PARK PLACE AT WESTCHESTER AIRPORT

Draft Supplemental Environmental Impact Statement

DRAFT SUPPLEMENTAL ENVIRONMENTAL IMPACT STATEMENT

March 22, 2016

DECIDUOUS SHRUB PLANTING
ON FLAT SLOPES (<10%)

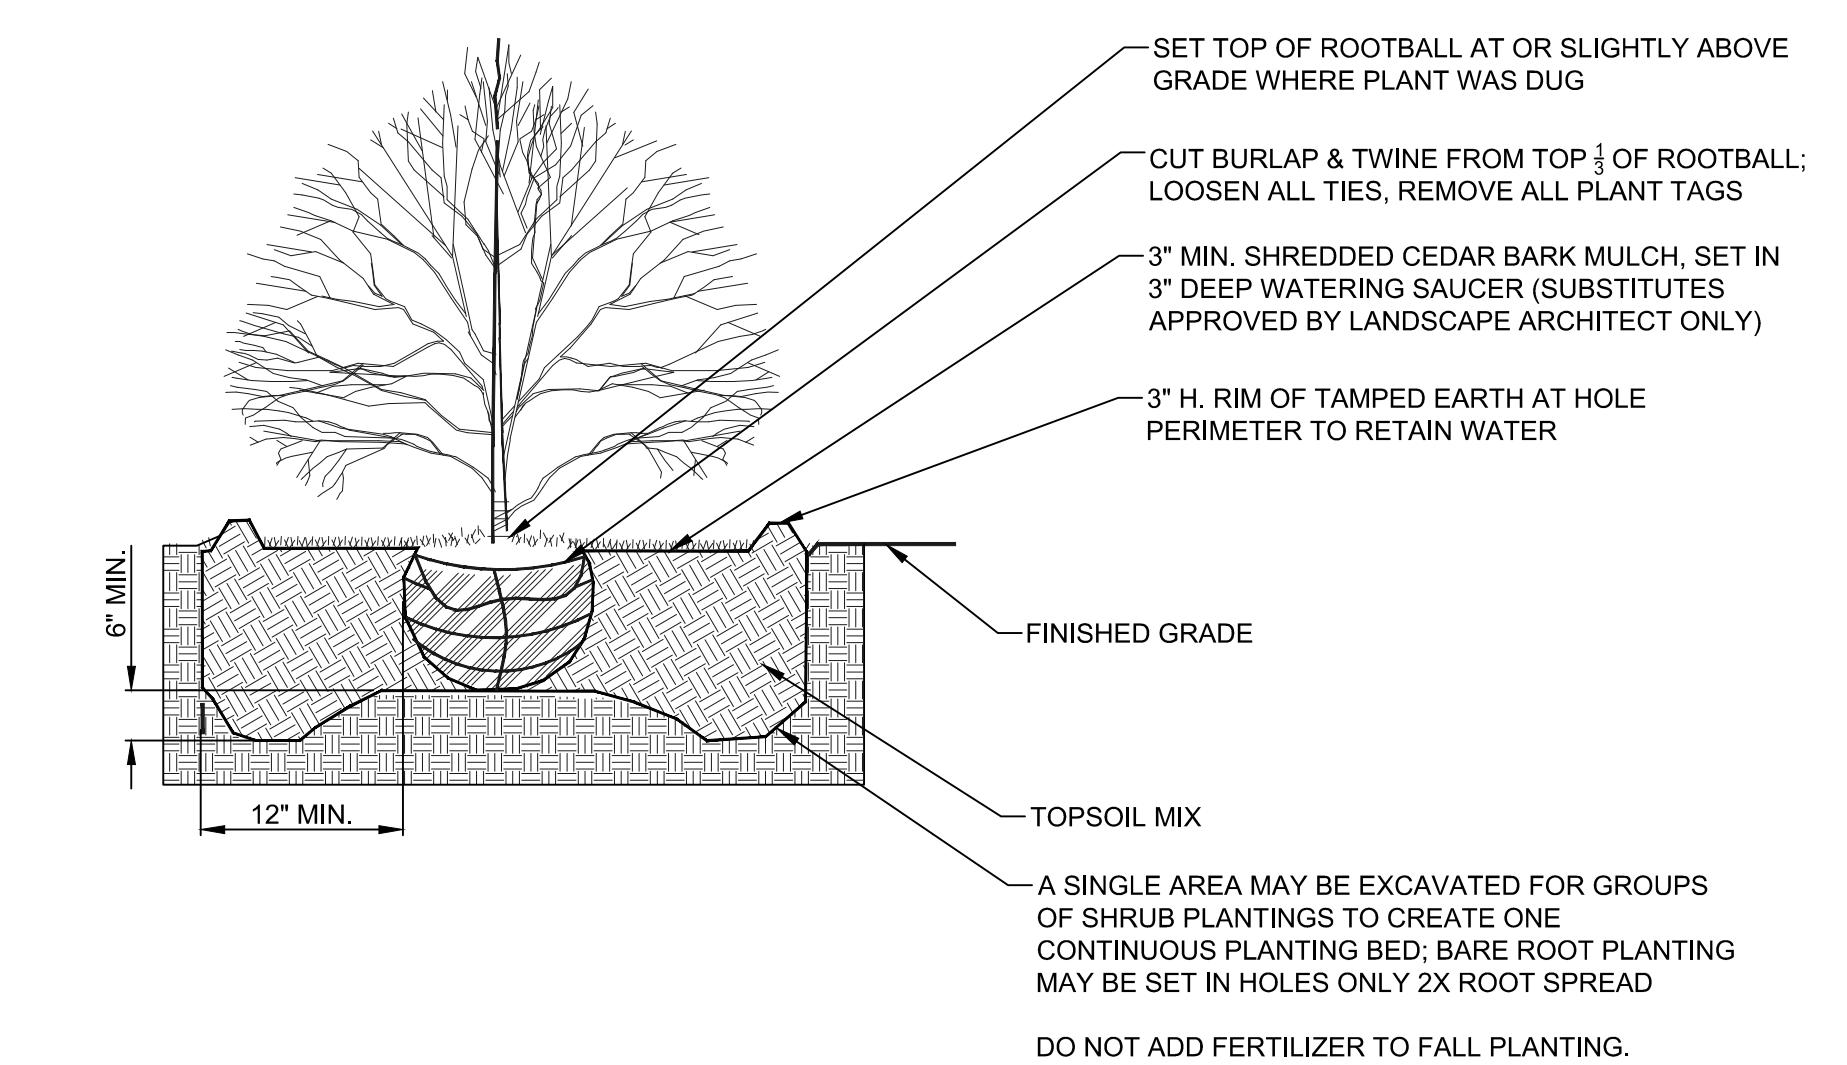
Comment 15: Drawing C-13 shows planting details for deciduous and evergreen trees, and deciduous shrubs on steep slopes. Note that the use of stakes, guy wires, and tree wrap is no longer considered to be standard practice and should only be used where trees are subject to high winds (for guying materials) and thin-barked trees to sun-scale (for tree wrap). Should the site have these conditions and use of these items is necessary, a note on the plan should then be added to require their removal prior to final acceptance (i.e., within 1 year following planting) of the landscaping. If these materials are left in place, there is a shigh likelihood they will eventually strangle the trees and/or harbor pests or diseases and cause mortality. (NYCDEP 2/12/15)

Comment 20: The data presented in the Stormwater Facility Profile shown on drawing C-13, Standard Details IV, is incorrect and does not agree with the current HydroCAD routing inputs and results. In addition, drawing C-13 shows the wetland permanent pool to be at elevation 377.5, while the HydroCAD routings start at pool elevation 378.00. The wetland outlet pipe elevation should be 372.5, instead of 368.5+/- shown on the drawing. Therefore, the entire Stormwater Facility Profile should be re-drawn once the correct elevations and dimensions have been established. (Office of the Watershed Inspector General, 2/19/15)

16. Drawing C-13 shows planting details for deciduous and evergreen trees, and deciduous shrubs on steep slopes. Note that the use of stakes, guy wires, and tree wrap is no longer considered to be standard practice and should only be used where trees are subject to high winds (for guying materials) and thin-barked trees to sun-scald (for tree wrap). Should the site have these conditions and use of these items is necessary, a note on the plan should then be added to require their removal prior to final acceptance (i.e., within 1 year following planting) of the landscaping. If these materials are left in place, there is a high likelihood they will eventually strangle the trees and/or harbor pests or diseases and cause mortality.

- a. The data presented in the Stormwater Facility Profile shown on drawing C-13, Standard Details IV, is incorrect and does not agree with the current HydroCAD routing inputs and results. The following table illustrates the inconsistencies between drawing C-13 and the HydroCAD values:

In addition, drawing C-13 shows the wetland permanent pool to be at elevation 377.5, while the HydroCAD routings start at pool elevation 378.00. The wetland outlet pipe elevation should be 372.5, instead of the 368.5 +/- shown on the drawing. Therefore, the entire Stormwater Facility Profile should be re-drawn once the correct elevations and dimensions have been established.

Response: Comment noted. The planting details on Drawing C-13 have been revised and the following note has been added to the Landscape Plan, Drawing C-9:
